# Field Safety Notice

## SBN-SIS-2019-002

### Loose screws on the Tray Input Flap of the cobas p 501 /p 701 post-analytical units

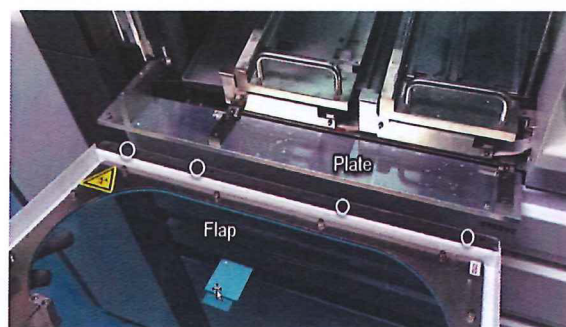
The Tray Input Flap screws can become loose on the cobas p 501 or p 701 post-analytical units resulting in the potential detachment from the instrument.

Visual inspection of the Tray Input Flap, plate and screws were performed. As demonstrated in the pictures below, the flap was no longer attached to the instrument and the 4 M3 threads on the Tray Input Flap were worn out resulting in the screws not working as intended.

The Tray Input Flaps on instruments with the above listed serial numbers must be replaced by Roche Diagnostics with the current design of the tray input flaps with an estimated completion date of 30-September-2019.

Prior to the replacement tray input flaps being installed, always inspect tray input flap to ensure the tray input flap is securely attached to the instrument. If the flap is not fastened securely or becomes loose prior to the tray input flap being replaced, please contact Roche Diagnostics to repair the instrument.
